RE: Administrative Subdivision Plan No. 620210120
HOC HQ

We have completed our review of the Administrative Subdivision Plan uploaded on eplans dated February 25, 2021. This plan was reviewed by the Development Review Committee at its meeting on February 16, 2021. We recommend approval for the plan based on the following comments:

SIGHT DISTANCE EVALUATION

Sight Distance Images Fenwick Lane Continued

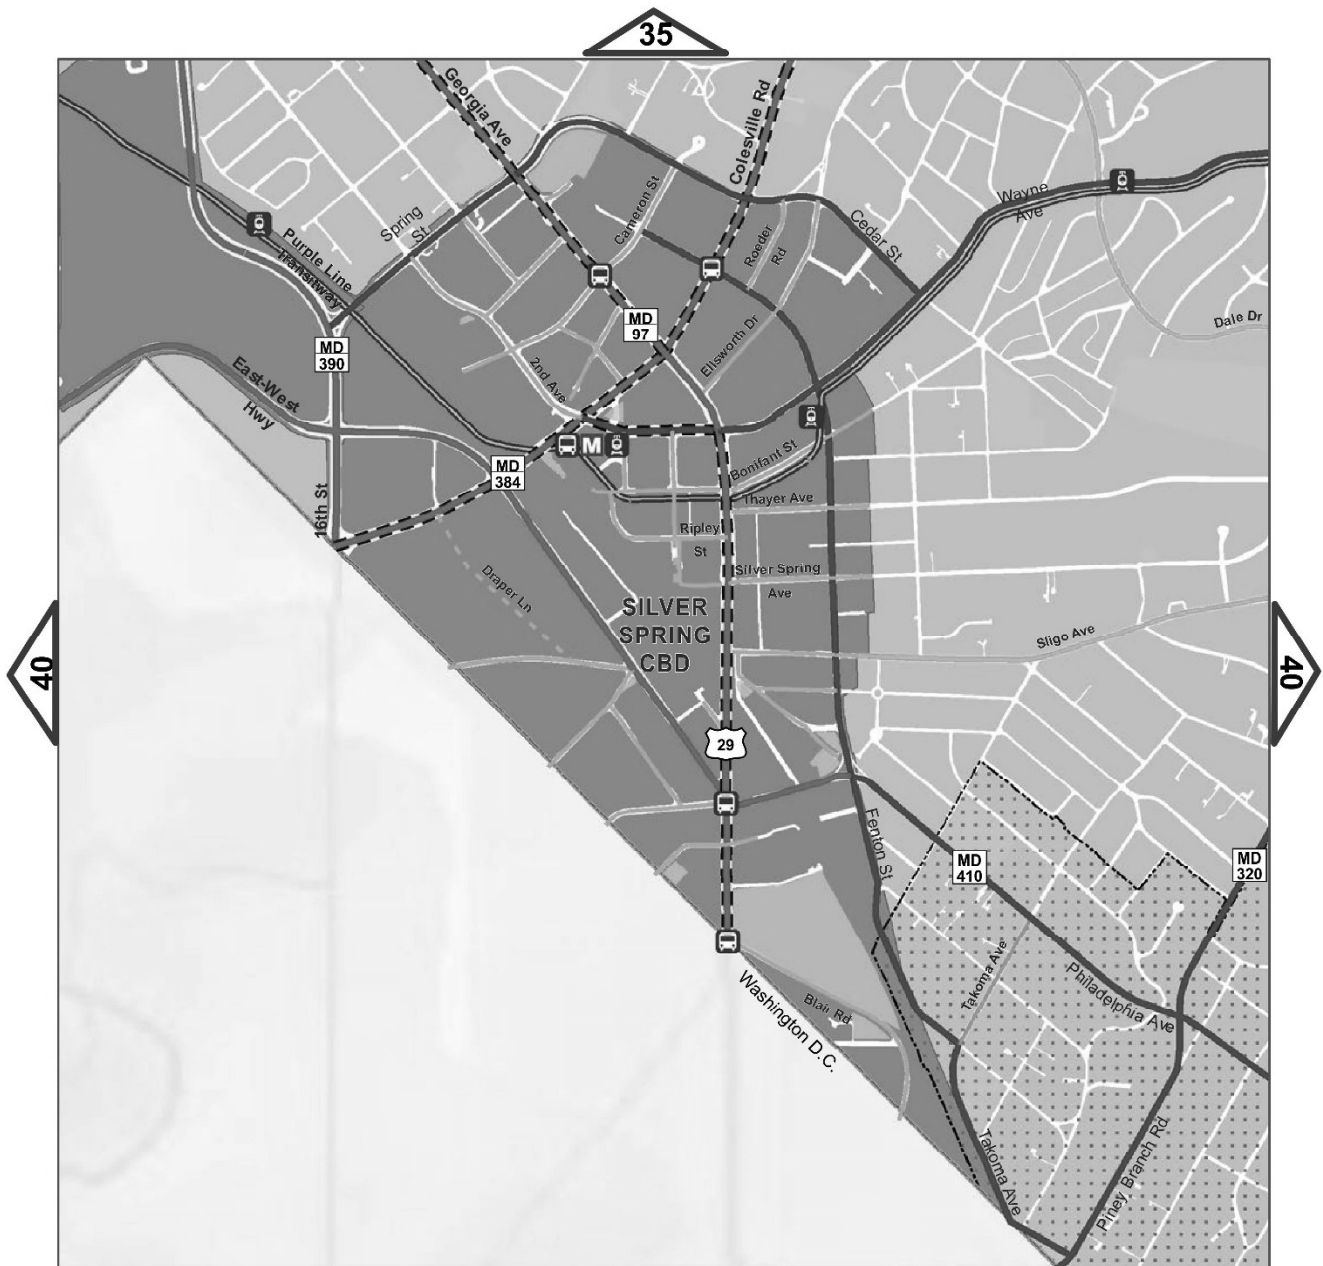
No

No

Comments: Parked Vehicles, Trash Receptacle and Mailbox Obstruct View in Portions of Sight Triangle; Center of Signalized Intersection +/- 165 Feet to the Left from Entrance. Without Parked Cars There is More Than Adequate Sight Distance.

- b. Fenwick Lane: Sight distance is **not required** as this access will be used as ingress only. At permit stage please coordinate with Traffic Engineering Section for the installation of proper traffic signs.
